Date: June 23, 2021
To: All Vendors
Subject: Addendum #1

REFERENCE: B 062-21 Southmost 2.0 MG Elevated Storage Tank

Addendum No. 1
B062-21 Southmost 2.0 MG Elevated Storage Tank
Brownsville PUB

ADDENDUM NO. 1
SOUTHMOST 2.0 MG ELEVATED STORAGE TANK

EST INTERIOR PLAN VIEW ADDENDUM #1

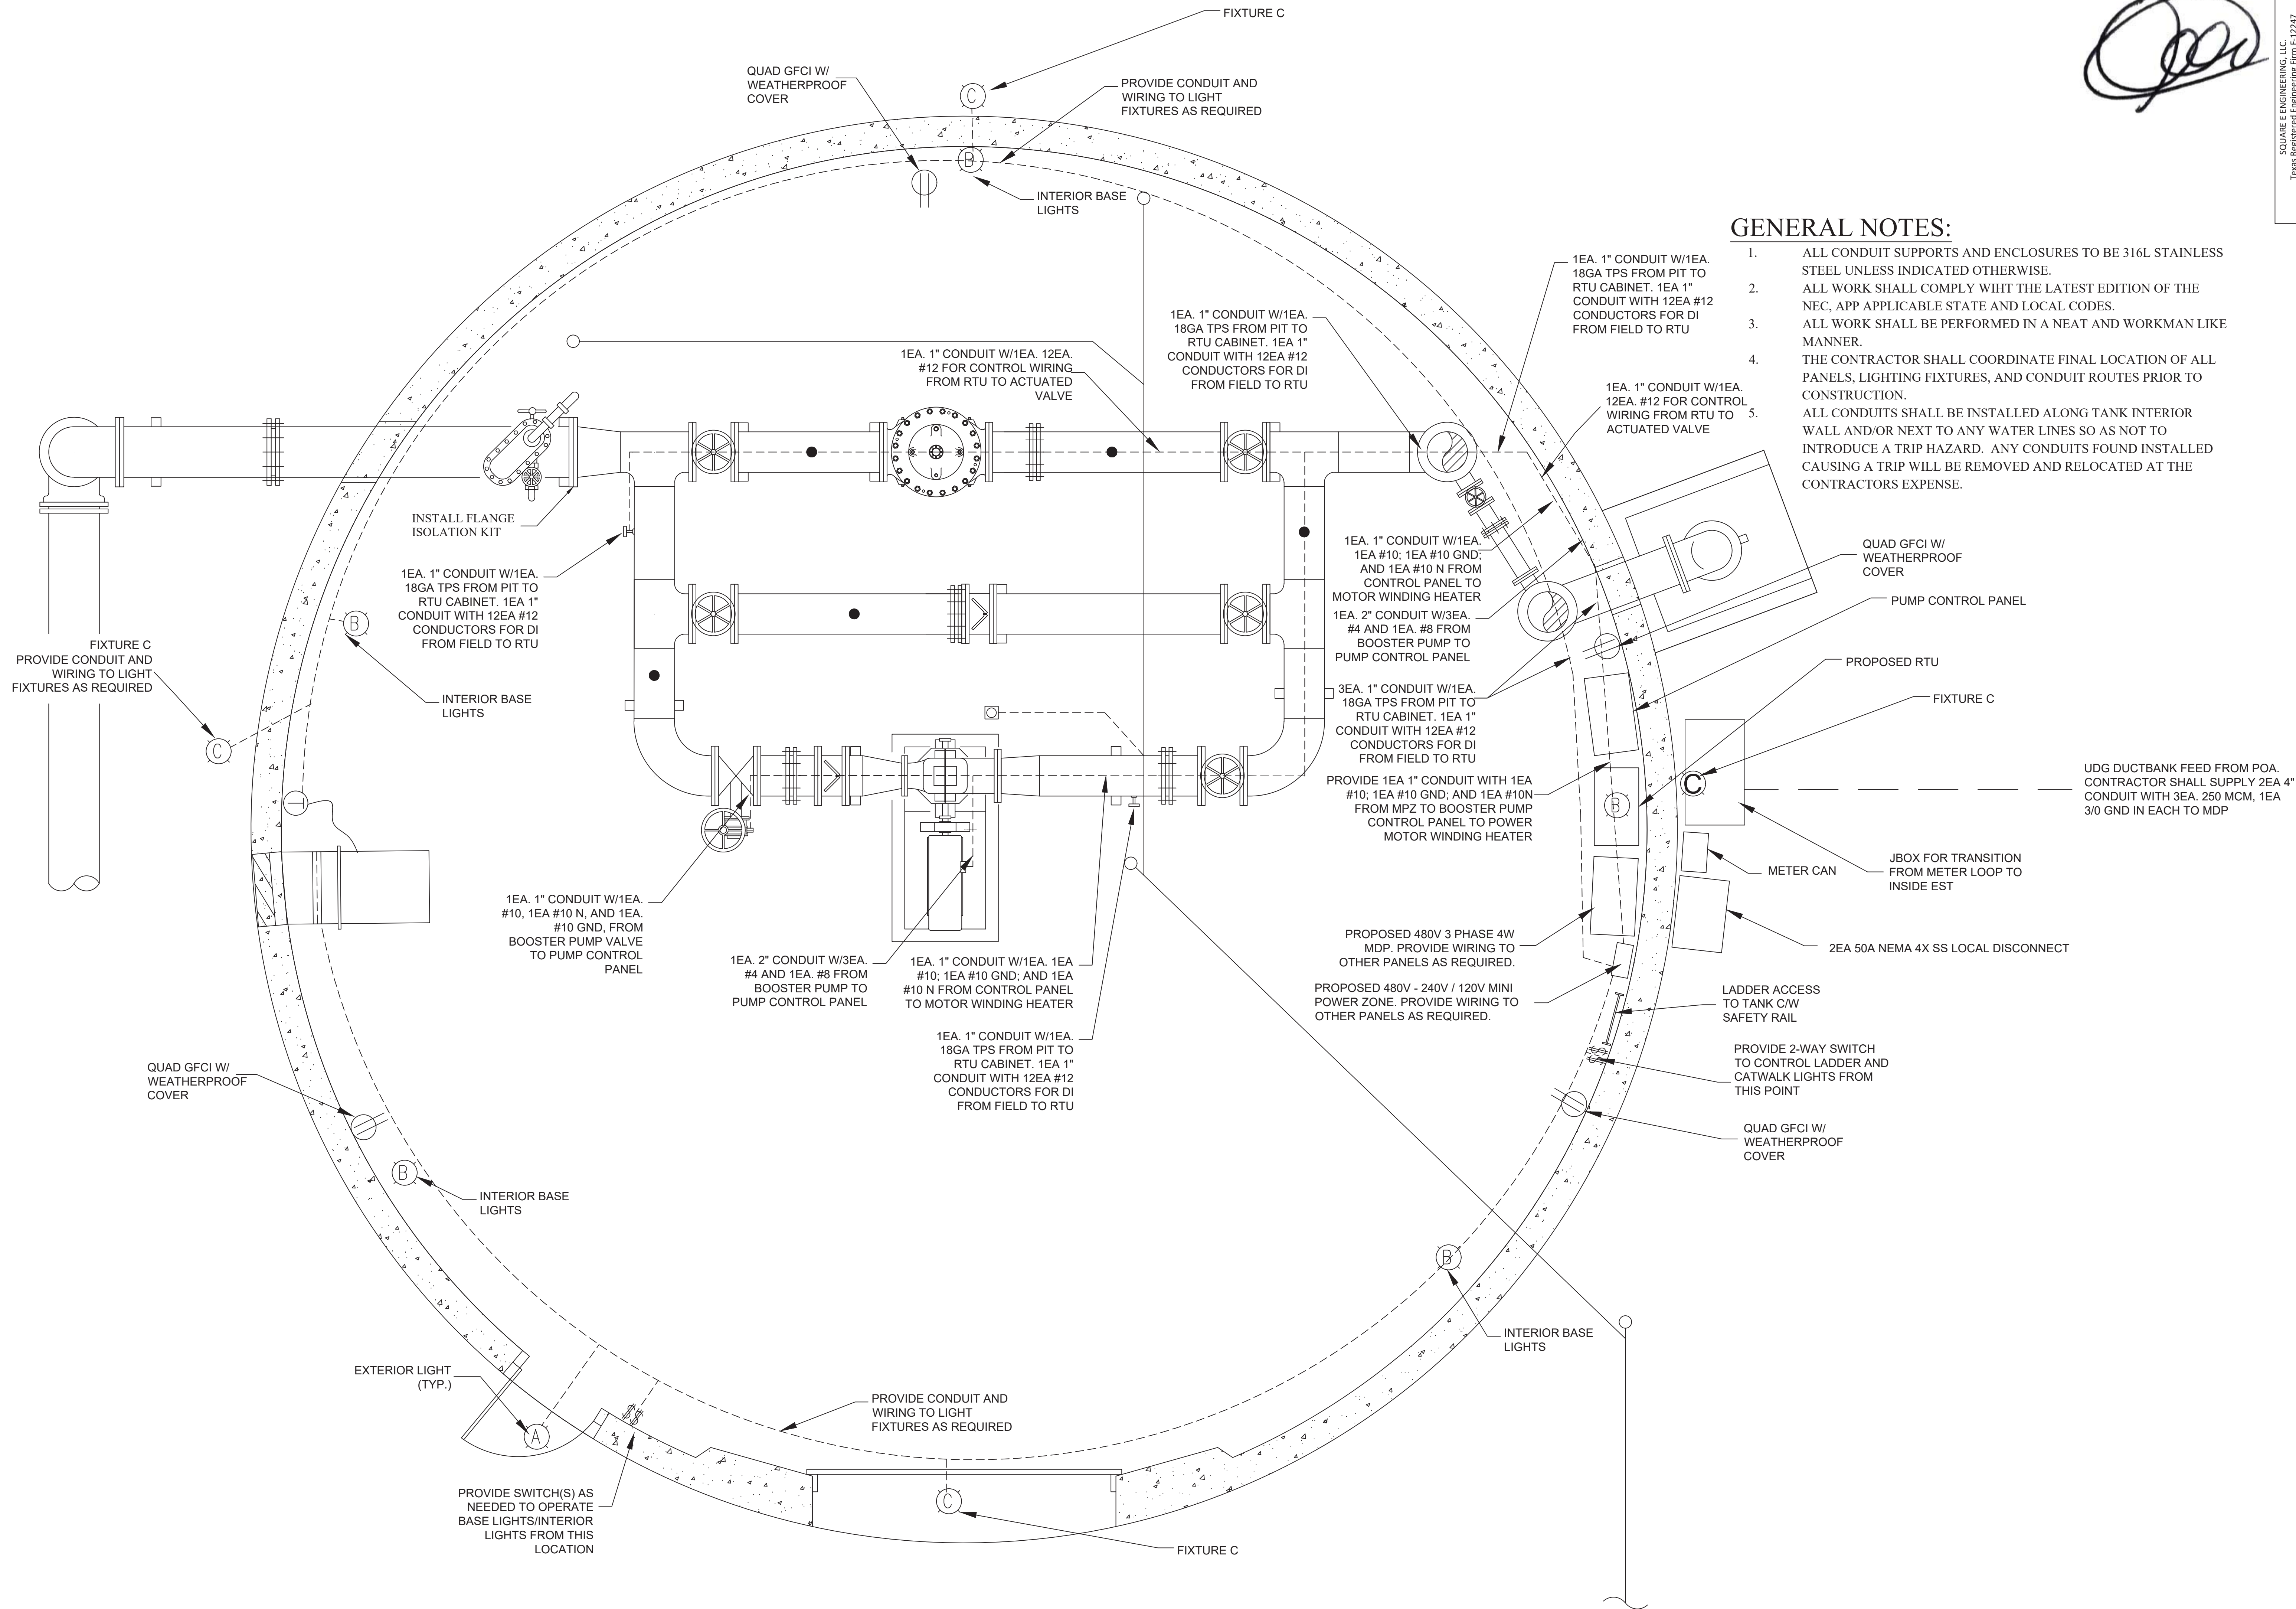
- h. Drawing "EST Interior Plan View" Sheet E3 is replaced with "EST Interior Plan View Addendum #1" Sheet E3 shown in the attachment provided by Square E Engineering.

- o The Bidders shall find these changes on drawing E2 submitted for Addendum #1 attached.
- Drawing E3
 - o The Bidders shall find the following changes on Drawing E3 submitted for Addendum #1 attached.

- o Additional callouts have been included to show routing of the addition of a power circuit to the motor heaters.
- Section 17711
 - o Sub Section Loop 100 from the original Bid Specifications shall be removed and replaced by the following Loop 100 loop description:
